Lumbini Ltd

Meghla, Bandarban, Chittagong
(+22.178294N, 92.190958E)

24th June 2014

Observations

Extensive cracking to the suspended floor slabs of the main building

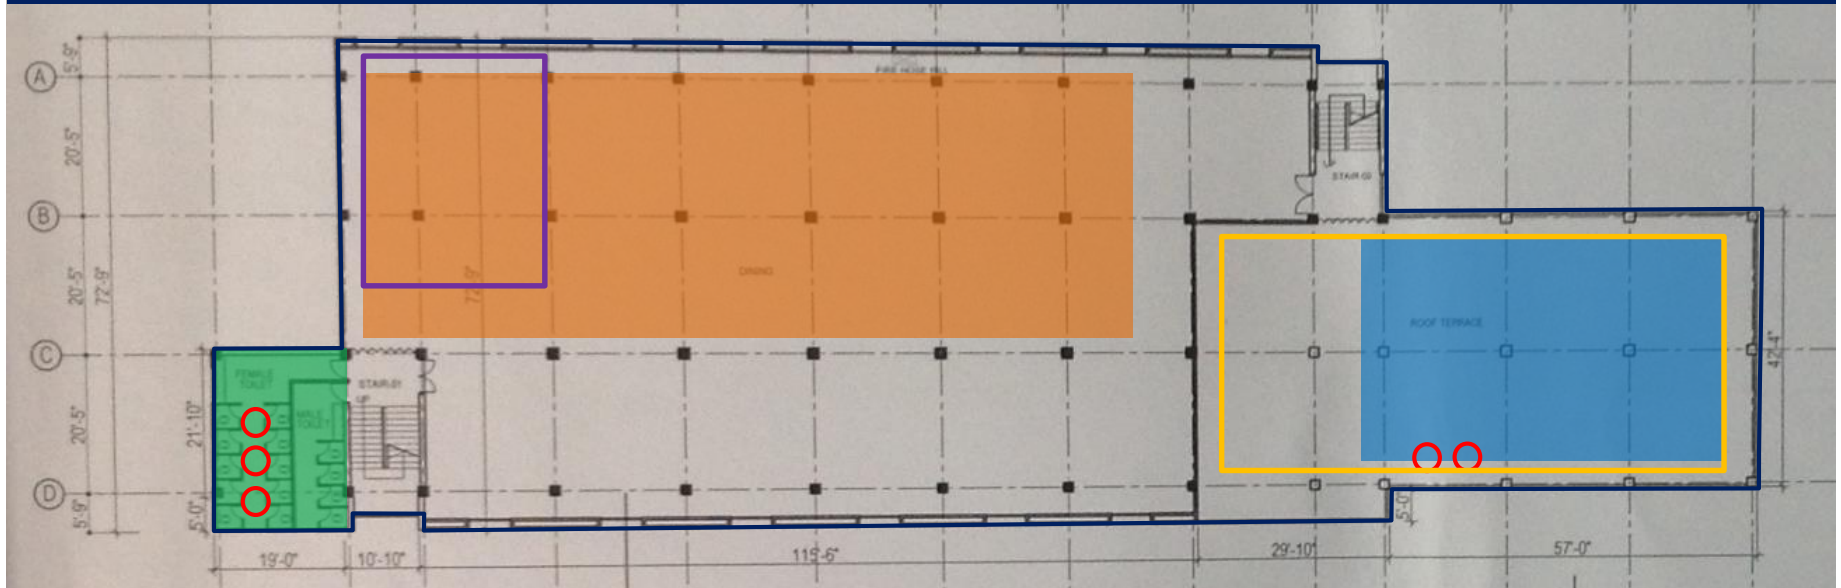
Extensive cracking of the floor slab was observed at all suspended floor levels. The cracking is in the structure, as the finishes are negligible. Repair works to cracks were also observed.

Cracking to top of slab

Cracking to top of slab

Cracking to top of slab

Cracking to soffit of the slab

Item No.	Observation	Recommended Action Plan	Recommended Timeline
1	Extensive cracking to the top and soffit of suspended floor slabs of the main building	Reduce loading on all floor plates to 2kPa pending review by Building Engineer.	Immediate - Now
2	Extensive cracking to the top and soffit of suspended floor slabs of the main building	Building Engineer to review extent of cracking to suspended floor slabs, and to prepare a schedule of actions, as required.	Immediate - Now
3	Extensive cracking to the top and soffit of suspended floor slabs of the main building	A Detail Engineering Assessment (DEA) of the main factory building to be commenced, see attached Scope.	Immediate - Now
4	Extensive cracking to the top and soffit of suspended floor slabs of the main building	Detail Engineering Assessment for the factory building to be completed.	6-weeks
5	Extensive cracking to the top and soffit of suspended floor slabs of the main building	Building Engineer to implement any actions as identified following the review and DEA, including load reduction / repair / strengthening of the slab if required.	6-weeks

Heavy Floor Loading

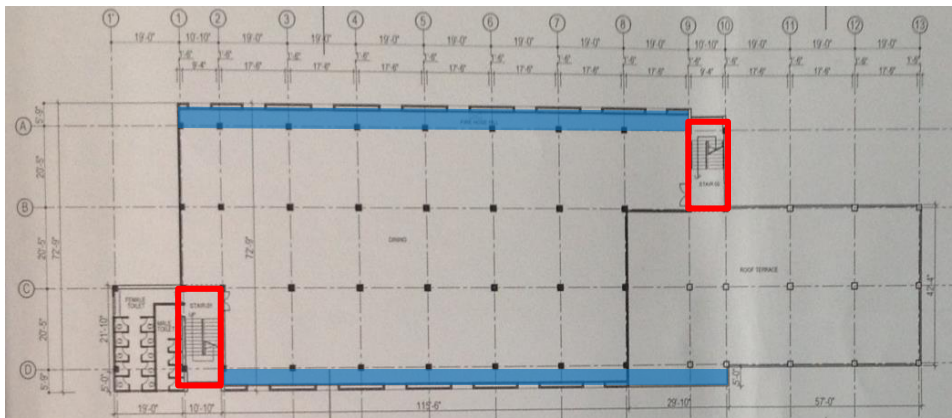
Areas of high loading were observed in:

- The storage areas at all floor levels
- The water tanks at 4th Floor/roof
- Jacquard machines at 2nd Floor level
- Toilet floor build-up at all floor levels.

While floor loading limits were displayed, these did not appear to be implemented.

Gazi water tanks at 4th floor level (capacity 2,000 to 5,000 l)

190mm (avg.) toilet floor build-up at all floor levels

Jacquard machines at 2nd Floor

Toilet build-up at all floor levels

Item No.	Observation	Recommended Action Plan	Recommended Timeline
7	Heavy floor loading and lack of a loading plan in the main building	As part of the Detail Engineering Assessment, Building Engineer to carry out a design check for loads due to water tanks, toilet areas, machines and storage areas (including temporary), and to advise on any necessary remedial works	6-weeks
8	Heavy floor loading and lack of a loading plan in the main building	Produce and actively manage a loading plan for all floor plates within the factory giving consideration to floor capacity and column capacity.	6-weeks
9	Heavy floor loading and lack of a loading plan in the main building	Factory Management to actively implement and manage a Loading Plans at each floor level.	6-months
10	Omissions and irregularities in design documentation	As part of the Detail Engineering Assessment, Building Engineer to carry out a design check to assess the safety and serviceability of the building, particularly in relation to lateral stability and element sizes.	Immediate - Now

Typical Floor Plan

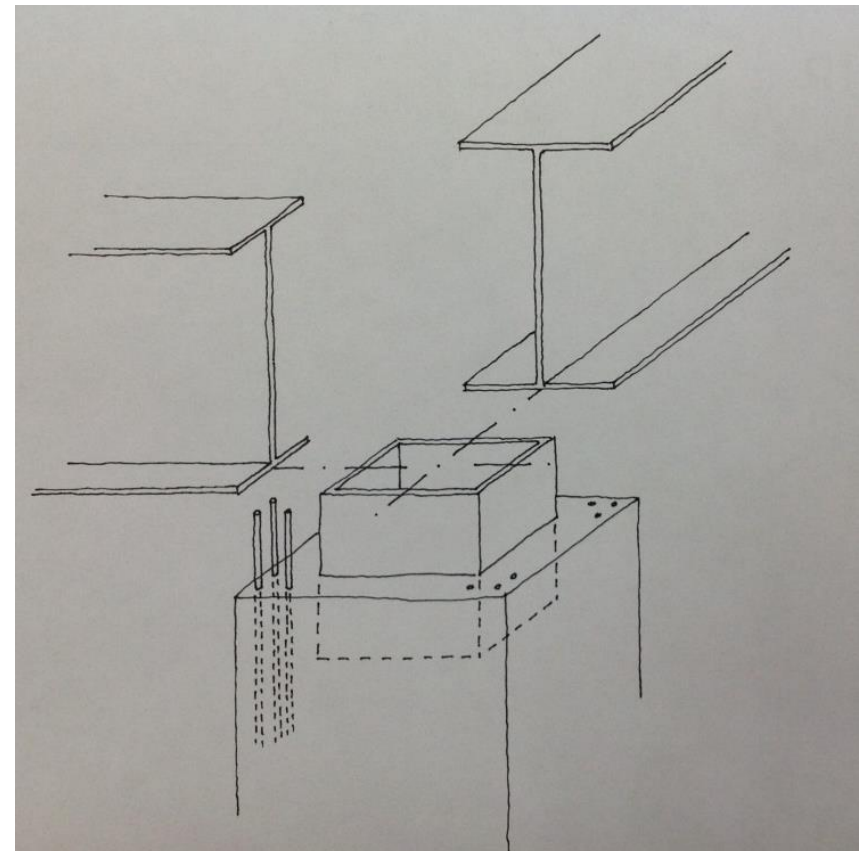
- There is a concern about the stability system for lateral loading conditions. The lateral stability of the building would appear to be provided primarily by moment-frame action; however, there is insufficient information in the design documents about the connection details between the primary steel beams and the RC columns – design check required.

Rigidity of RC column to beam connection is not clear

Sketch – Typical beam-column detail is unclear

Masonry walls supported on cantilever beams

Stairs cores comprising brick infill walls

Lateral stability concerns – There is insufficient information about the structure / connection between members to justify moment-frame action

11	Omissions and irregularities in design documentation	Building Engineer to survey all areas of the building, collect information and prepare a full and accurate set of “as-constructed” drawings, with special emphasis on connection details.	6-weeks
12	Omissions and irregularities in design documentation	Building Engineer to carry out comparison between design specified member sizes and as constructed structure.	6-weeks
13	Omissions and irregularities in design documentation	Building Engineer to implement any actions / supervise any remedial works as identified following the design check.	6-months

Extract from soil investigation report references a 3 storey , not a 5 storey, building

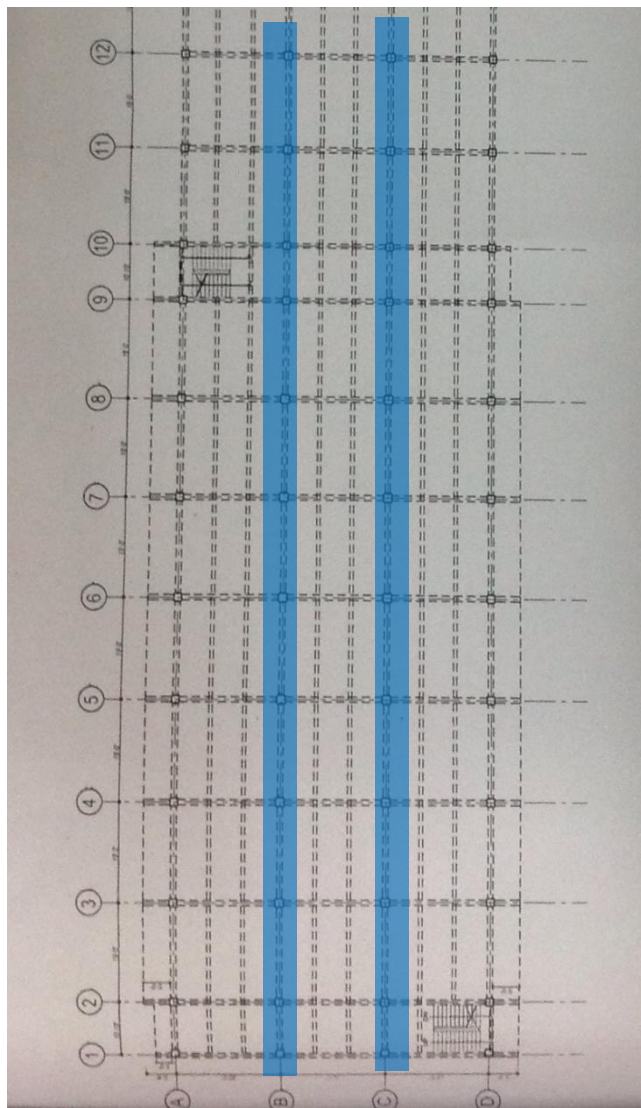
- The foundation recommendations provided in the soil investigation report make reference to a 3 storey building, not a 5 storey building – clarification required.

Column and beam layout

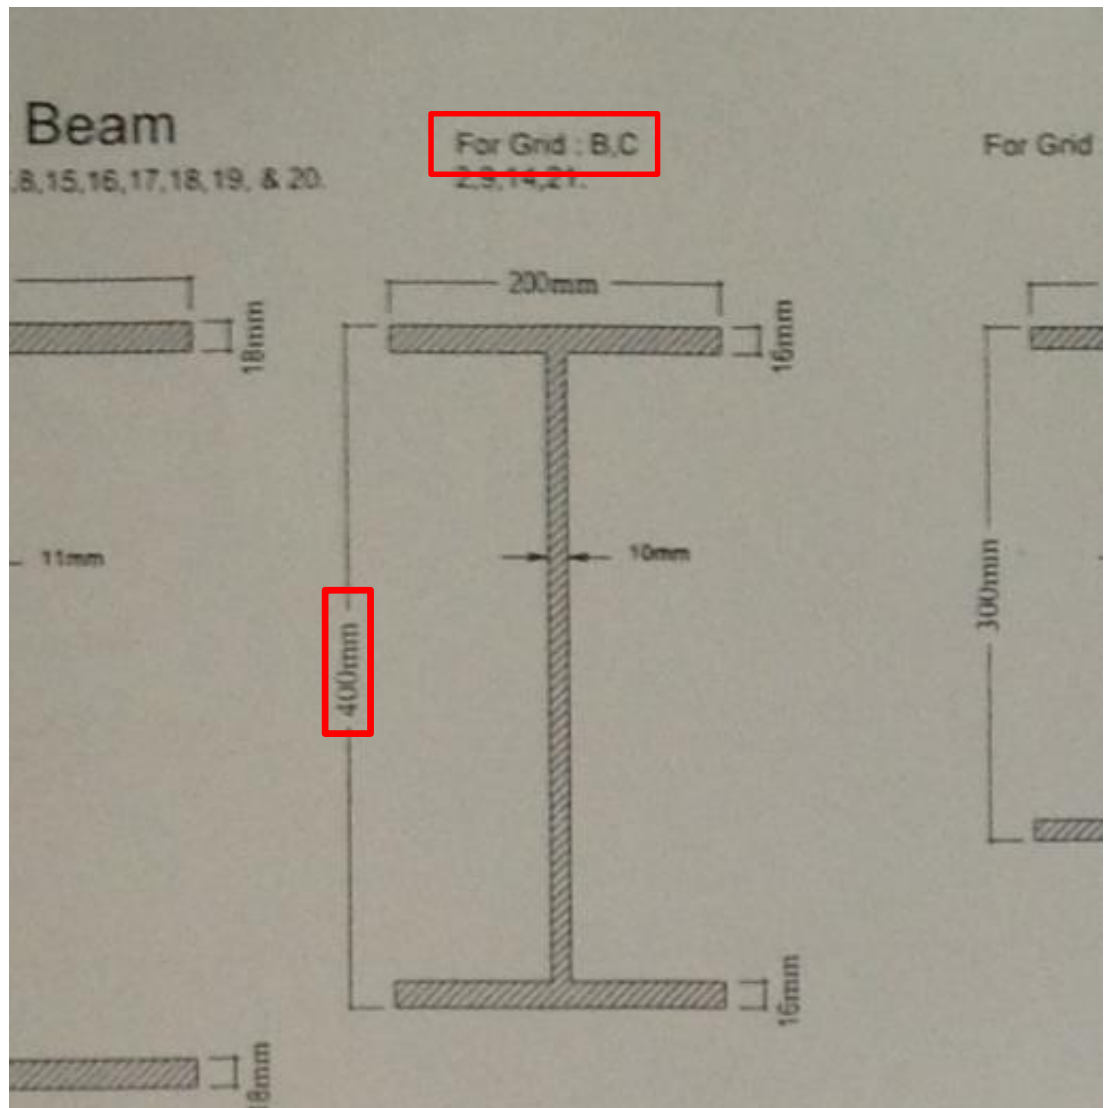
- A number of steel beams are smaller than specified: for example, the structural drawings indicate 400mm deep beams along gridlines B and C, whereas these were measured to be 300mm deep – design check required.

- The structural drawings indicate an expansion joint between gridlines 9 and 10, which does not appear to have been incorporated. It is planned that the building will be extended South beyond the proposed location of the movement joint – design check required.

Expansion joint indicated on the as-built structural drawings – not apparent on site

Steel beams along G.L. B and C – Specified as 400mm deep on the drawings, but measured as 300mm deep

Ground Floor Plan

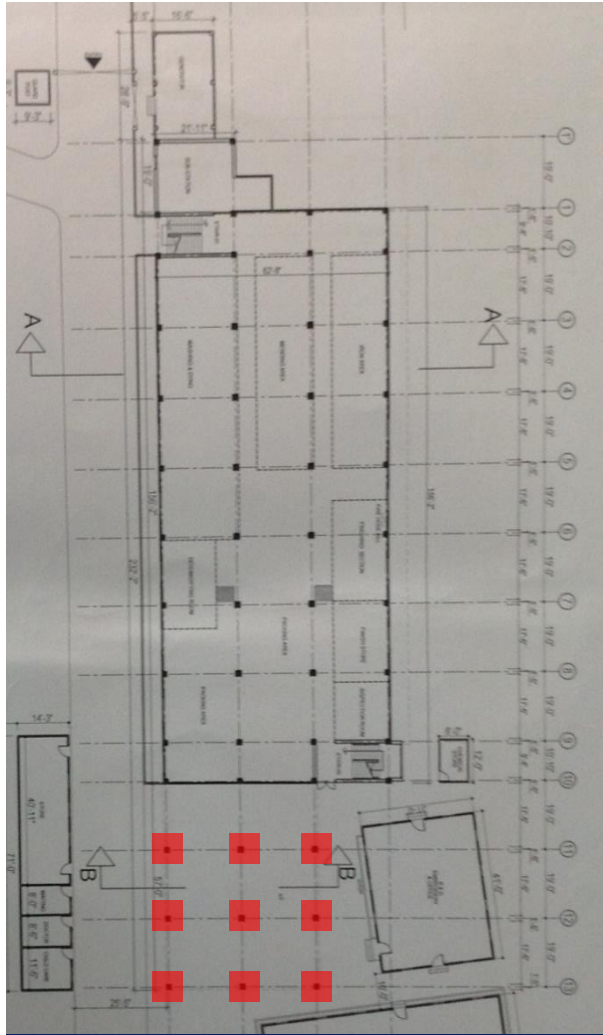
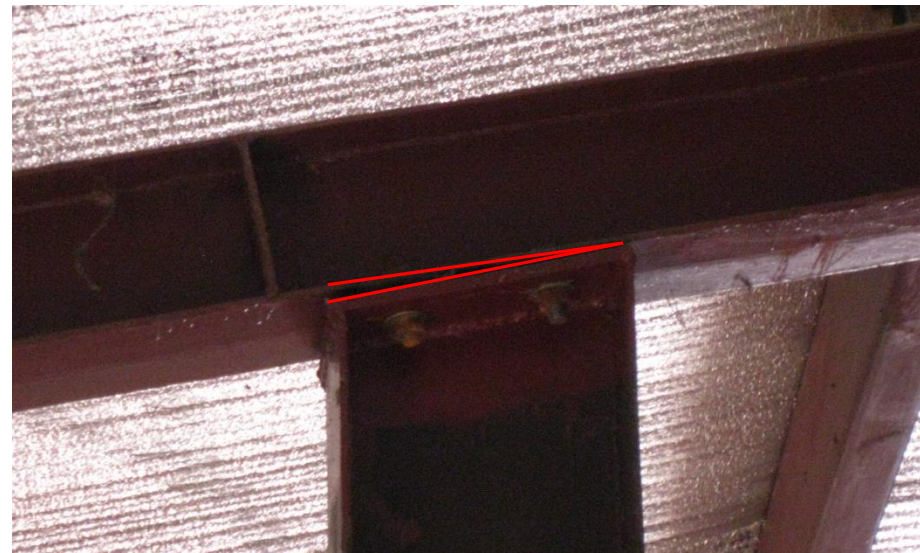
The double-height columns to the south of the building, adjacent to the delivery entrance, are at risk of being accidentally struck by a vehicle. The existing column protection appears inadequate.

Columns adjacent to parking area

Two-storey Ground Floor columns at risk of vehicle impact

Item No.	Observation	Recommended Action Plan	Recommended Timeline
14	Double-height columns at risk of impact loading	As part of the Detail Engineering Assessment, Building Engineer to assess whether the columns have been adequately designed for impact loading.	6-weeks
15	Double-height columns at risk of impact loading	Suitable column protection barriers to be designed and constructed.	6-weeks
16	Lightweight and non-engineered structures	Building Engineer to review the design of all lightweight structures within the compound and assess their ability to withstand wind loading pressure, suction and uplift forces, with special emphasis on connections and bracing.	6-weeks
17	Lightweight and non-engineered structures	Building Engineer to implement any actions / supervise any remedial works as identified following the review.	6-months

Lightweight Structures

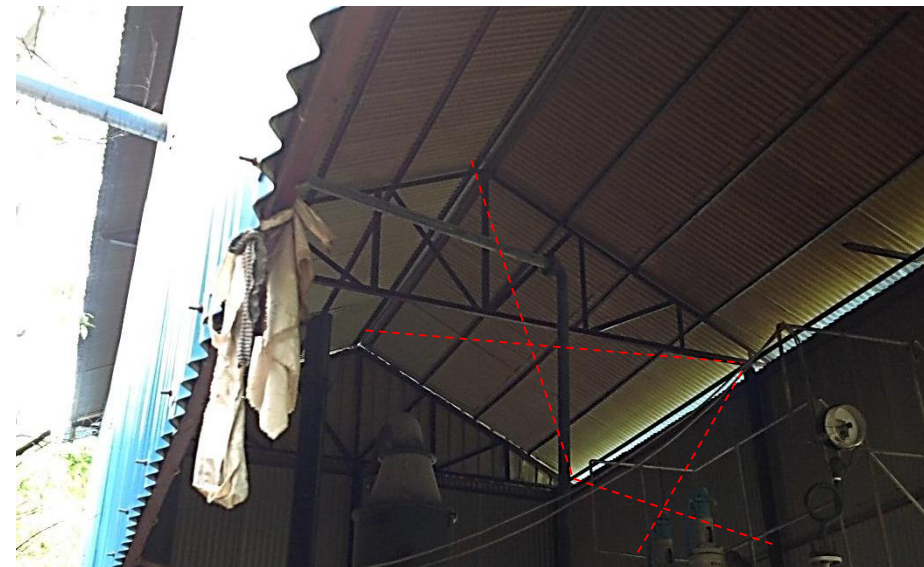
There are elements of these structures which appear to be non-engineered and not designed to resist uplift forces and lateral loads, particularly in relation to bracing and connection details.

Roof shed - lack of horizontal bracing

Inadequate bearing at beam-column connections

Shed to roof – Beam to RC column connection unclear

Boiler shed – Lack of horizontal and vertical bracing

Store Shed – Lack of horizontal and vertical bracing

Generator Shed – Roof connection details unclear

Wastage store – Sagging timber purlins
